SURRY POWER STATION, UNIT NO. 1

AMENDMENT TO FACILITY OPERATING LICENSE

Amendment No. 170  
License No. DPR-32

ATTACHMENT TO LICENSE AMENDMENT

TS FIGURE 2.1-1

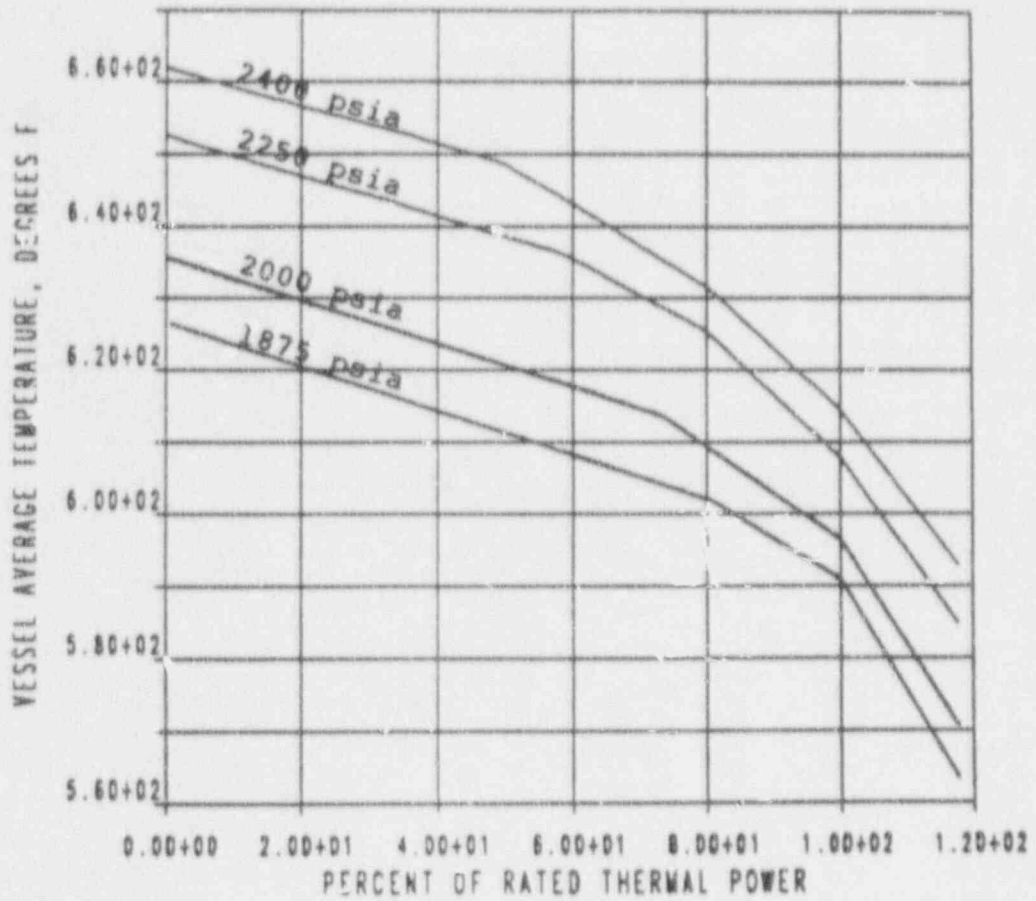
TS Figure 2.1-1 is based on an  $F\Delta H(N)$  of 1.62, a 1.55 cosine axial flux shape, and a deterministic DNB analysis procedure including margin to accommodate rod bowing<sup>(1)</sup>. TS Figure 2.1-1 is also bounding for a statistical treatment of key DNBR analysis parameter uncertainties including an enthalpy rise hot channel factor which follows the following functional form:  $F\Delta H(N) = 1.56 [1 + 0.3(1-P)]$  where P is the fraction of rated power. TS Figures 2.1-2 and 2.1-3 are based on an  $F\Delta H(N)$  of 1.55, a deterministic treatment of key DNB analysis parameter uncertainties, and include a 0.2 rather than 0.3 part power multiplier for the enthalpy rise hot channel factor.

TS FIGURE 3.12-8

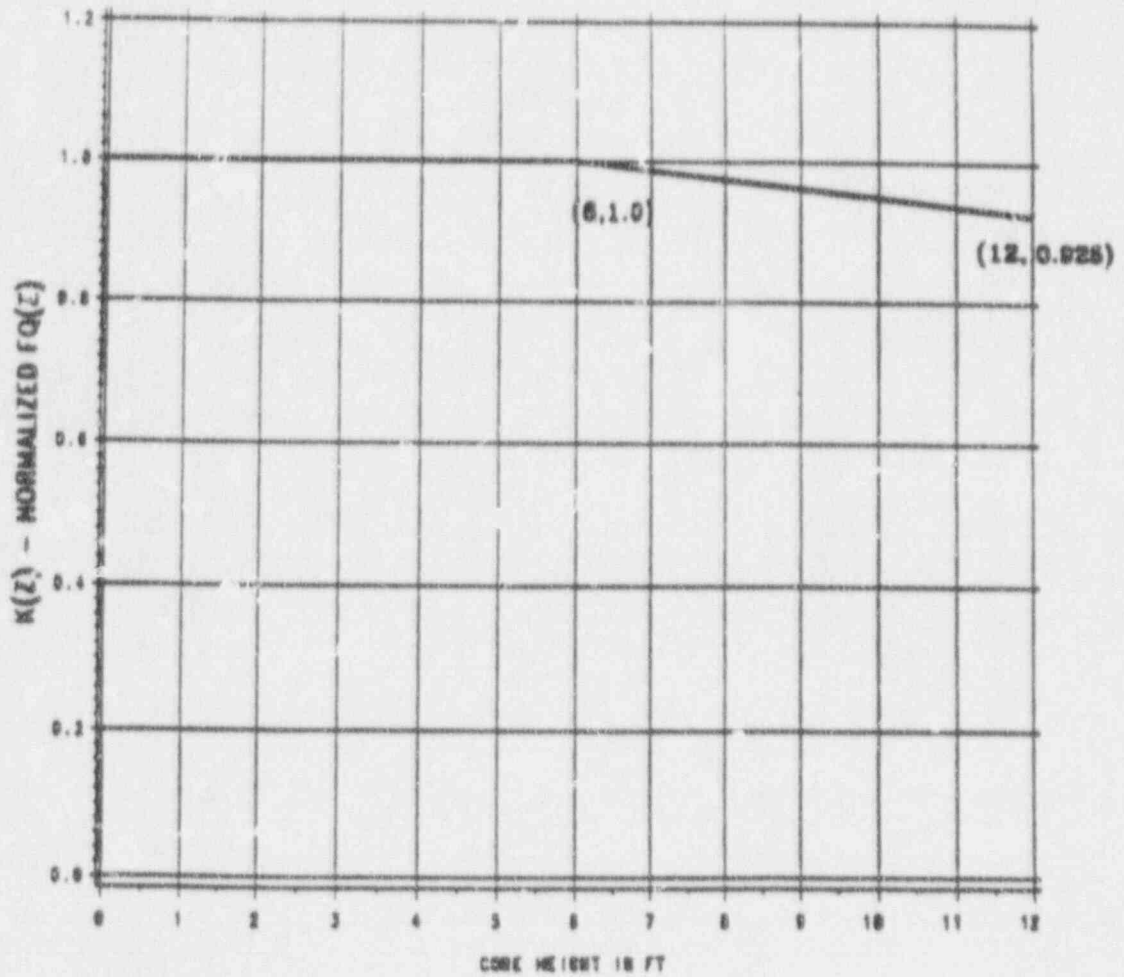
where P is the fraction of rated power at which the core is operating, K(Z) is the function given in TS Figure 3.12-8, and Z is the core height location of  $F_Q$ .

It should be noted that the enthalpy rise factors are based on integrals and are used as such in the DNB and LOCA calculations. Local heat fluxes are obtained by using hot channel and adjacent channel explicit power shapes which take into account variations in radial (x-y) power shapes throughout the core. Thus, the radial power shape at the point of maximum heat flux is not necessarily directly related to the enthalpy rise factors. The results of the loss of coolant accident analyses are conservative with respect to the ECCS acceptance criteria as specified in 10 CFR 50.46 using the upper bound  $F_Q(Z)$  times the hot channel factor normalized operating envelope given by TS Figure 3.12-8.
